REPOSE TO THE ARCHITECTURAL CONSULTANT COMMENTS LETTER DATED 10-19-21 AND THE E-MAIL FROM SEAN MULLIN AT THE PLANNING DEPARTMENT DATED 01-28-22:

16484 Kennedy Road - Parcel 2
Design Review Comments
October 19, 2021 Page 4

REAR ELEVATION

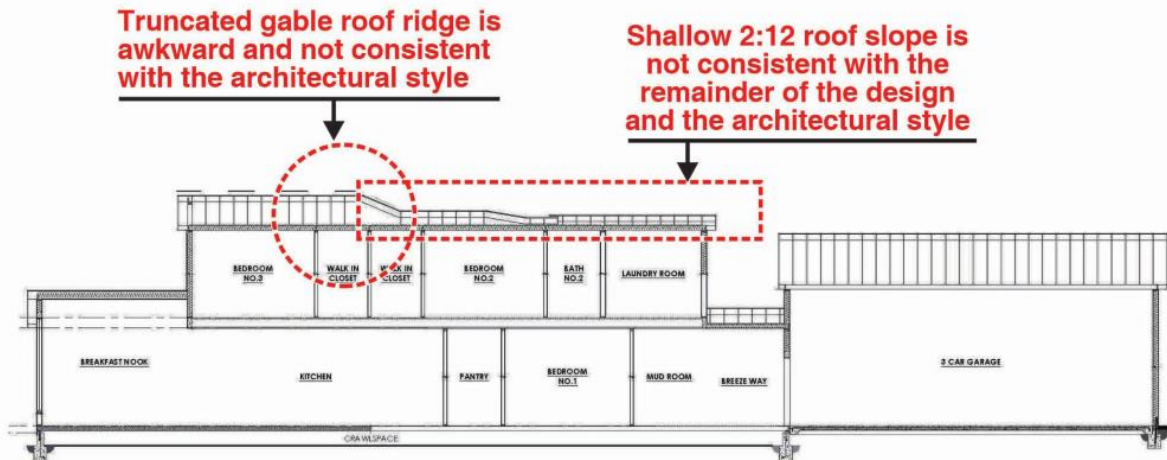
1. The wide difference in roof slopes and heights, including 2:12 and 5:12 slopes, is visually awkward, and do not work well in creating a unified design. It appears as though a traditional style, large home has been scrunched down, unnecessarily except for a one-size-fits-all universal requirement in the Town's *Hillside Standards and Design Guidelines*. And, this variation in roof slopes is not consistent with Residential Design Guideline 3.5.1.

Shallow 2:12 roof slope is not consistent with the remainder of the design and the architectural style

We have completely redesigned the roof system to create one unified roof slope to unify the roof pitches and eliminate complexity. We also increased the height of the roof slope to 3:12 to elevate the height of the roof so that it is more consistent with the Residential Design Guidelines 3.5.1 and 3.5.2. See revised exterior elevations Sheets A5-1 and A5-2.

LEFT SIDE ELEVATION

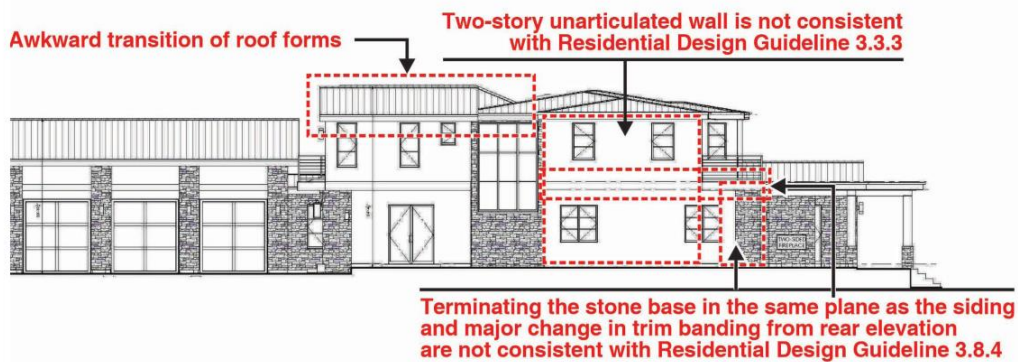
2. The truncated roof ridge and full rear gable on the front of the house are awkward, and not consistent with the architectural style.

4. The two-story unarticulated wall on the right and left side elevations are not consistent with Residential Design Guideline 3.3.3.

The truncated gable has been removed to eliminate the inconsistency with the architectural style. We have also unified the roof slope to one pitch and elevated the roof slope to 3:12 to elevate the height of the roof so that it is more consistent with the Residential Design Guidelines 3.5.1 and 3.5.2. See revised exterior elevations Sheets A5-1 and A5-2 and Roof Plan A4-1.

The truncated gable has been removed. The two-story unarticulated walls have also been modified for visual relief using a continuous lower roof eave that matches the front and rear lower roof eaves to be consistent with Residential Design Guideline 3.3.3. The termination in the stone base has been addressed by wrapping the stone veneer around so that it terminates into a wall as per Residential Design Guideline 3.8.4. See revised exterior elevations Sheets A5-1 and A5-2.

LEFT SIDE ELEVATION

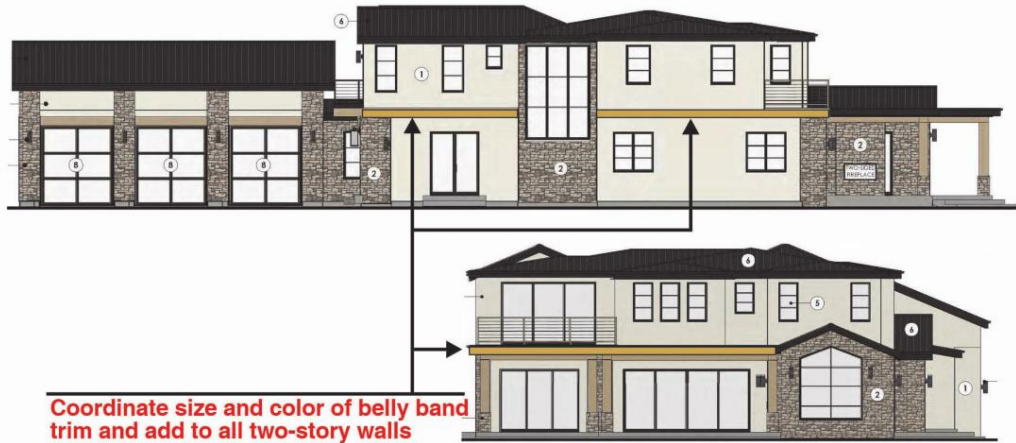
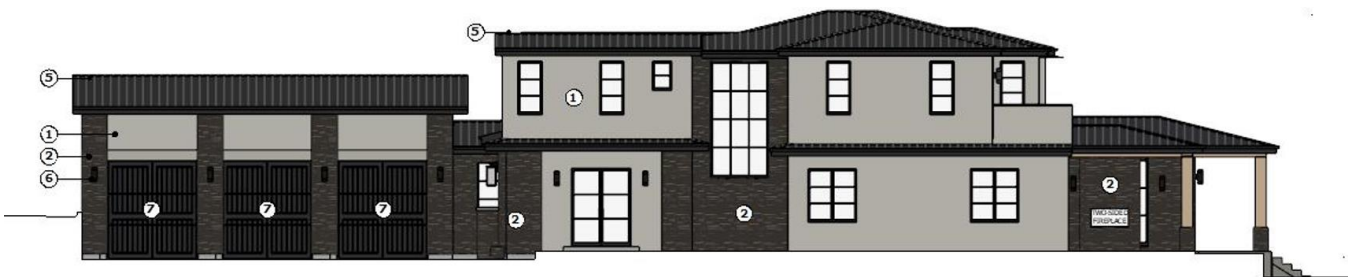
2. Coordinate the size and color of the belly band trim, and add to all unarticulated two-story walls.

The belly bands have been completely removed in favor a roof eave line at the first-floor to create one continuous line around the home instead of breaking up the wall sections with a belly band to create continuity as per the Residential Design Guidelines. See revised exterior elevations Sheets A5-1 and A5-2.
